### DEPARTMENT OF THE AIR FORCE AIR FORCE CIVIL ENGINEER CENTER

Subject: Response to Need for Continued Extraction for Containment Site ST012 - Former Williams Air Force Base (AFB), Mesa, Arizona

# Responses to EPA/ADEQ Joint Letter – Need for Continued Extraction for Containment at ST-12 Fuels Spill Site, Former Williams AFB, Mesa, AZ

## Attachment 2 Responses to EPA April 29, 2016 email questions

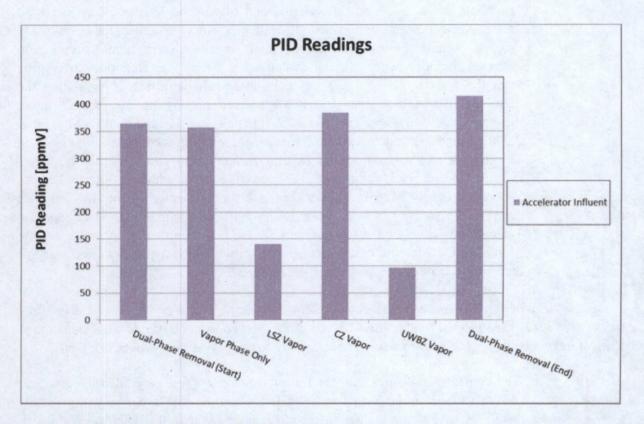
b. "The contaminant sources for the recent vapor mass recovery (dissolved phase and volatilized contaminants in extracted steam or air) are likely masses of residual LNAPL remaining in the TTZ (and other soil volumes previously heated to steam temperature)."

Response: In the last week of post-steam extraction, a study was conducted to evaluate where the vapor mass was originating. The extraction system was sequentially operated through a sequence to isolate each zone and take PID and flow rate measurements. Time was provided (approximately 45 to 60 mins) to allow flushing of the vapor system. The sequence of tests was as follows:

A graph presenting the PID readings at the thermal accelerator influent is provided below.

This data indicates that the CZ is contributing most of the mass in the vapor phase since the vapor mass removal rate when only the CZ was open to extraction was close to the mass removal rates during normal operations (vapor and liquid extraction) and vapor only extraction from all three zones. This observation is consistent with previous technical explanations because this zone has more open screen for vapor extraction available and vapors extracted through this zone would, in part, capture mass from the vadose zone (such as the deep vadose zone intervals addressed by the deep SVE well screens). This observation is not consistent with the agencies suggestion that masses of residual LNAPL within the TTZ are the likely primary source of vapor mass recovery. However, as discussed below, SEE wells will be checked and monitored for LNAPL.

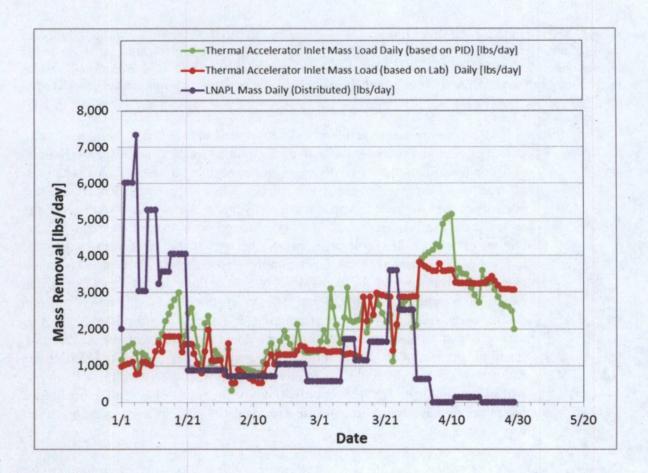
"LNAPL columns likely reside in extraction well casings. The bottom of such LNAPL columns may exist above the pump intakes because of limited drawdown and therefore LNAPL does not appear in jar tests. This LNAPL is not recovered by pumping but can supply vapors for extraction. If so, the persistence and increase in vapor mass recovery indicates this LNAPL is being replenished from a "reservoir" of NAPL around such extraction wells. If the bottom of the LNAPL column is below the top of the screen intervals it is hydraulically connected to the formation for replenishment. Recent mass vapor extraction rates exceed the equivalent of 300 gallons/day of LNAPL. Each casing has a capacity on the order of 50 gallons therefore, if this LNAPL is the source of extracted vapors, the formation is replenishing the LNAPL in the casing as fast as it is removed. The drawdown increased with the cessation of steam injection and likely contributes to the increased vapor recovery rate. If the water levels in the extraction wells are allowed to rise, the vapor mass recovery will likely diminish. That reduction will not be the result of LNAPL remediation but rather hydraulically disconnecting residual LNAPL in the formation from vapor extraction."

Response: While LNAPL volumes could exist in well casings, this is a conceptual explanation for the vapor mass recovery that doesn't have any direct measures to verify it. SEE wells are in the process of being opened and checked for the presence of NAPL layers. If NAPL is present, the wells will be included in routine NAPL monitoring/removal activities. The recent testing described above suggests that the CZ is the primary source of vapor mass. Further, the significant increases of vapor mass removal during depressurizations are delayed from the drawdown associated with depressurization (see mass removal graph below, with depressurizations between 28 December to 21 January, 5 February to 18 February, and 4 March to 29 April), which would not be consistent with an LNAPL reservoir in close proximity to the well casing.
